Reference #: 3020730

Address: 3447 22nd Avenue W
Decision Design Review; Environmentally Critical Area; Environmentally Critical Area Exception;
Elements: Subdivision; SEPA;

RE: Parcel 2770601540 50'x120' proposed subdivision

Correction Notice #3

Figure 1 and 2: Existing Site Plan with only 5 of 7 arborist-indicated existing trees shown (above). And (below) the Seattle 2007 Tree Canopy map with property outlined in red.

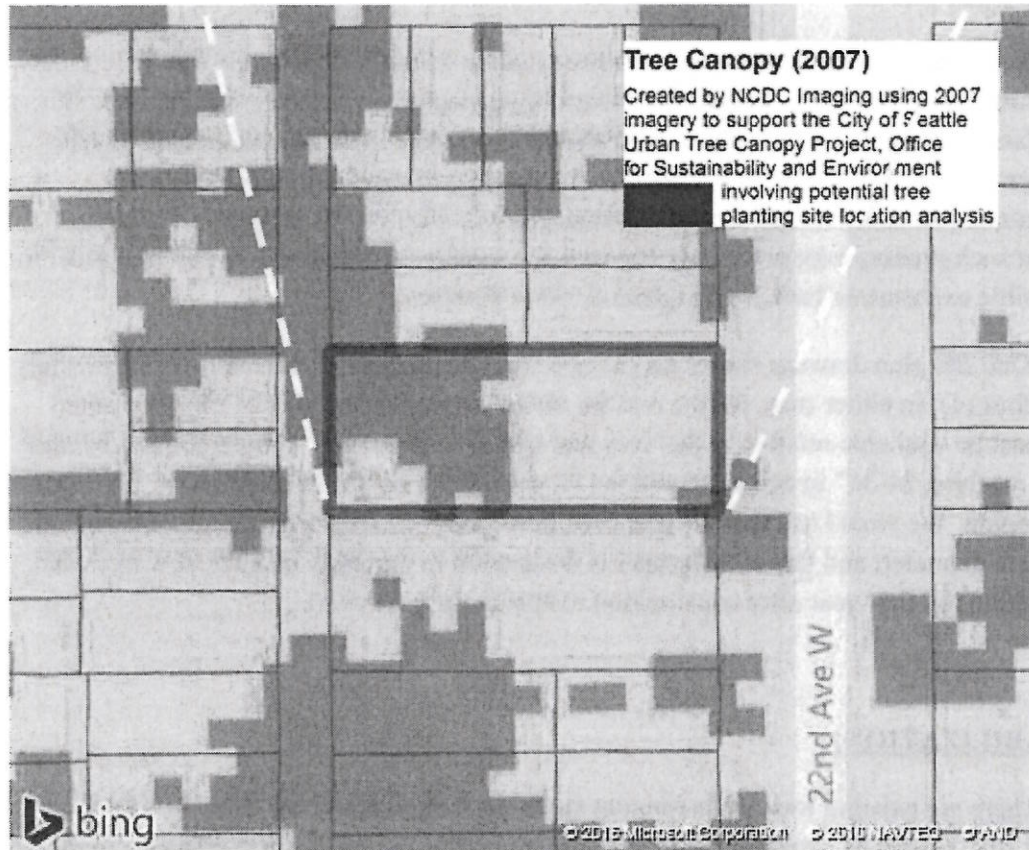
[Item T1] There are seven (7) existing trees listed on the Site Plan arborist report, yet the drawings only show five (5) existing trees (see Figure 1 on following page). Trees listed by arborist:

[Item T2] Of the five trees shown on the Site Plan, *all are indicated to be removed* regardless of their relationship to proposed building locations. Given the contributions of trees to the areas eco-system, we (the neighbors) would like to save as many trees as possible. This will involve reconsidering the temporary excavations as currently shown on the site plan.

[Item T4] There exists at least two trees, noted as CH8 and S8, which are within close proximity of along the property boundary that should *not* be removed and should be protected from root or limb damage during construction.

[Item T6] There exists at least two trees, both labeled as CH6, that are within the critical slope area (as shown within hatched area of Site Plan) that should *not* be removed. The new buildings are not within this portion of the site, and there appears to be no apparent reason to remove the trees within this area.

SLOPE SECTIONS
Scale: 1/16"=1'-0"

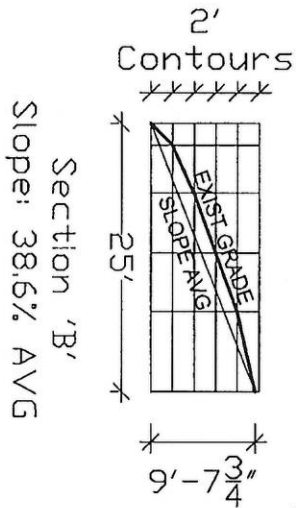
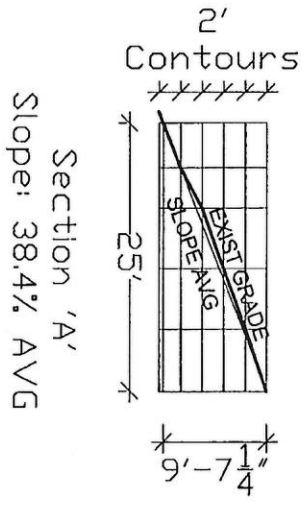
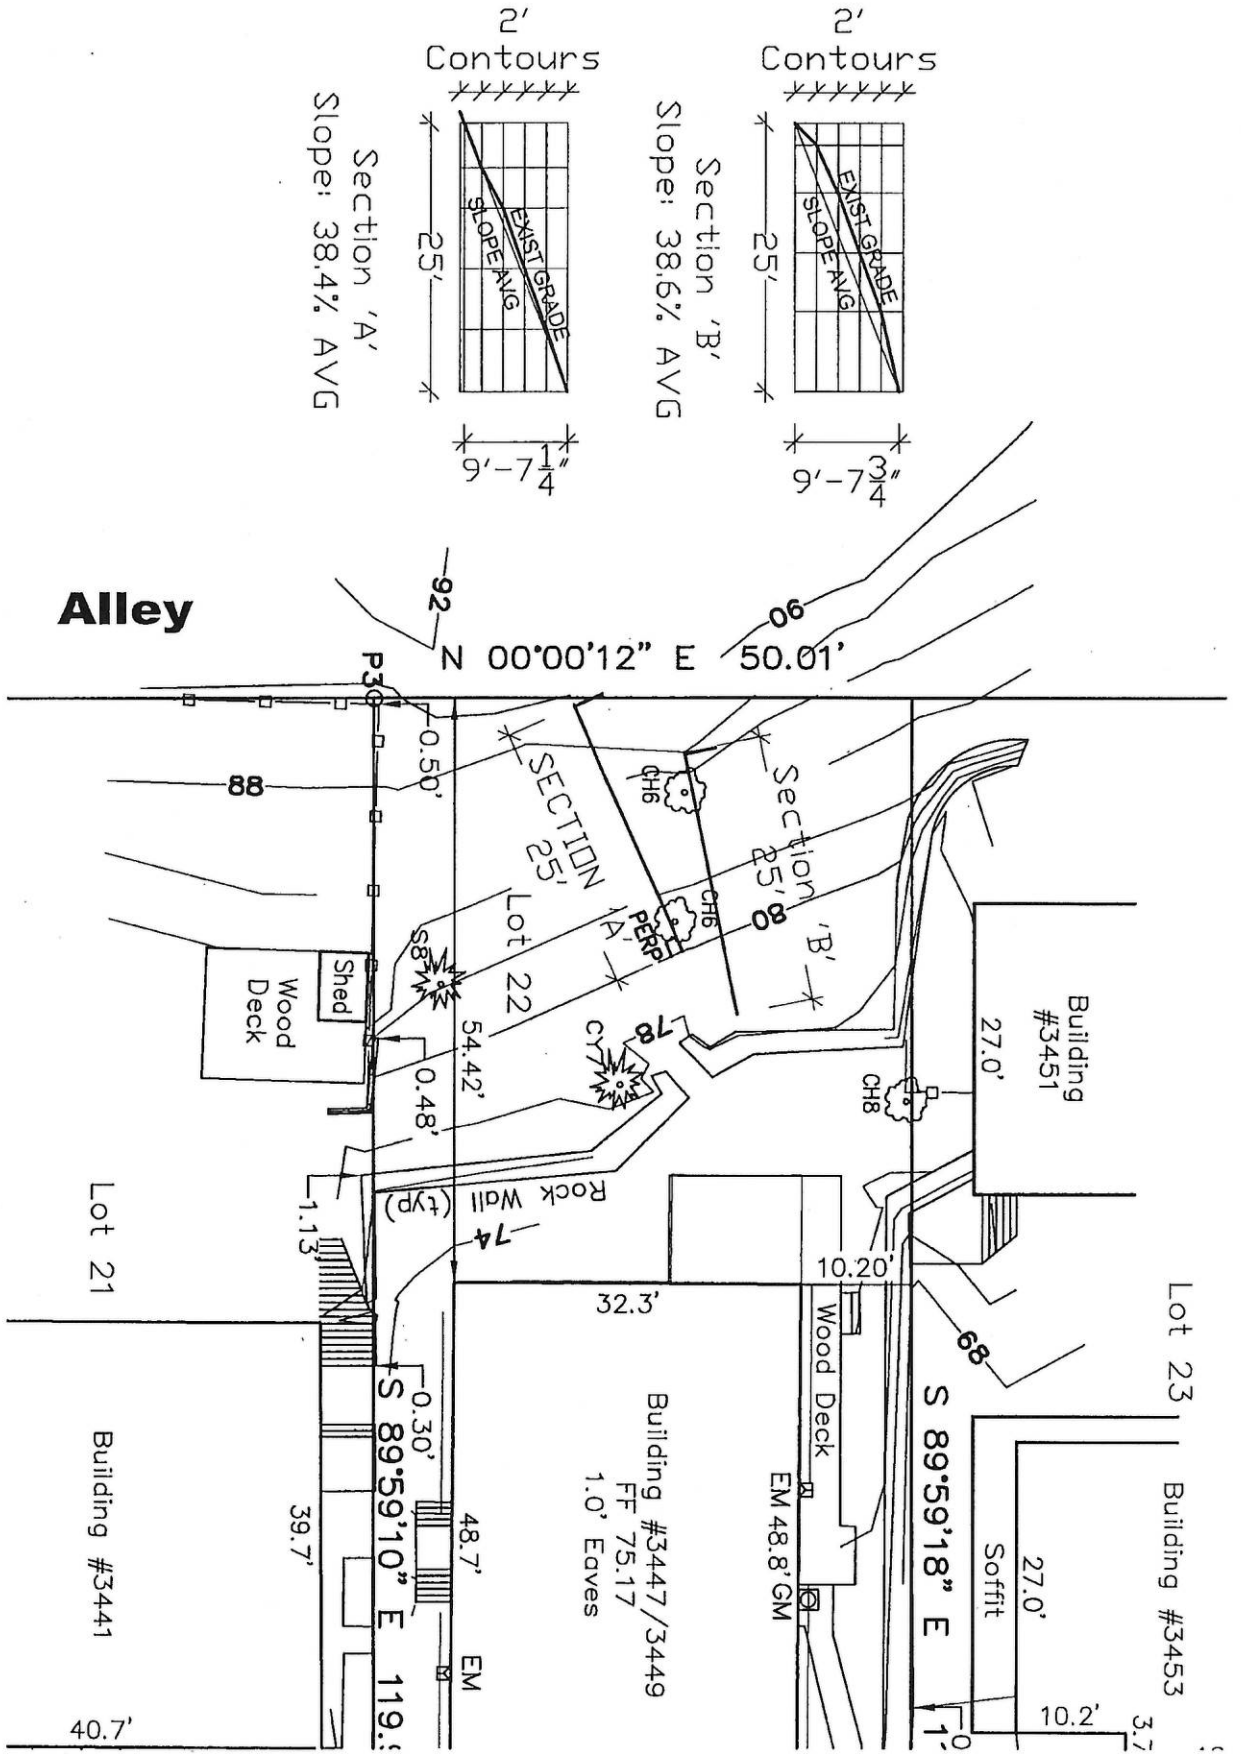
Sheet A1.0. Please adjust the Steep Slope Critical Area to be consistent with that shown on the attached site plan. Label this area as "Steep Slope Critical Area."
- 2 SMC 25.09.330 B.6. and SMC 22.170.070 B.2.c. Site Grading

Provide a temporary excavation plan demonstrating that adjacent properties will be protected during construction activities. The excavation plan does not need to be at final design level for this phase of permitting.

Show on the plans the permanent proposed grade contours. The final grade contours need to match the existing grade contours, as shown on the topographic survey, at the property lines.

1. REVISED TO SHOW REVIEWER DELINEATION. ALSO ATTACHED ARE GEOTECH ASSESSMENT, WHICH SHOWS THAT THE GENERAL SLOPE ON THE LOT IS NOT 40% (SEE ATTACHED BELOW). IT WOULD APPEAR THAT THE NEIGHBOR'S WALL TO THE NORTH HAS CREATED THE STEEP SLOPE SITUATION...WE REQUEST A STEEP SLOPES EXEMPTION TO TO THAT MAN MADE CONDITION.
2. A1.2 revised with a finished grade plan, showing every 2' contours connection with it's respective grades at property line.

A1.0

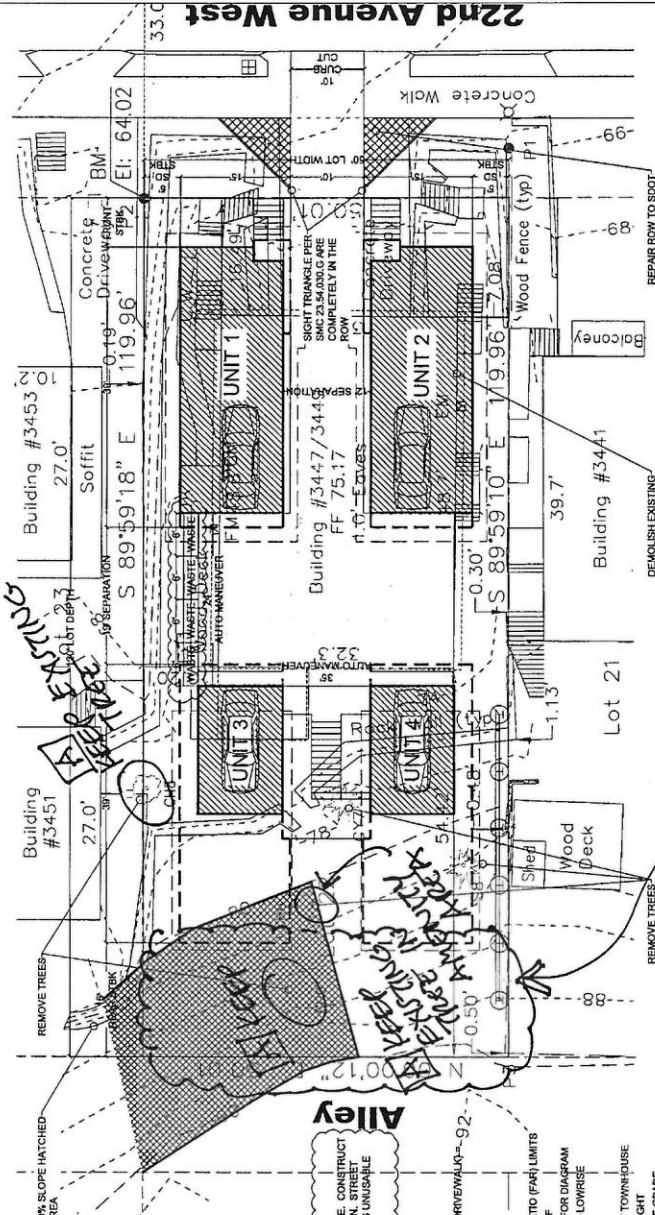
WHY DISTURB/REPLACE MATURING TREES IN THIS PART OF SITE WITH NO NEW CONSTRUCTION & NO NEW RETAINING WALLS?

SEE A1.1 & TOPO SURVEY OF CHERRY OR APPLE TREES THAT SHOULD REMAIN

SEE SHEET A1.2 FOR EXCESSIVE TEMPORARY EXCAVATION LINES. INSTEAD, WHY ARE TEMP. EXCAVATIONS DEEP ON WEST END & SHALLOW ON NORTH & SOUTH?
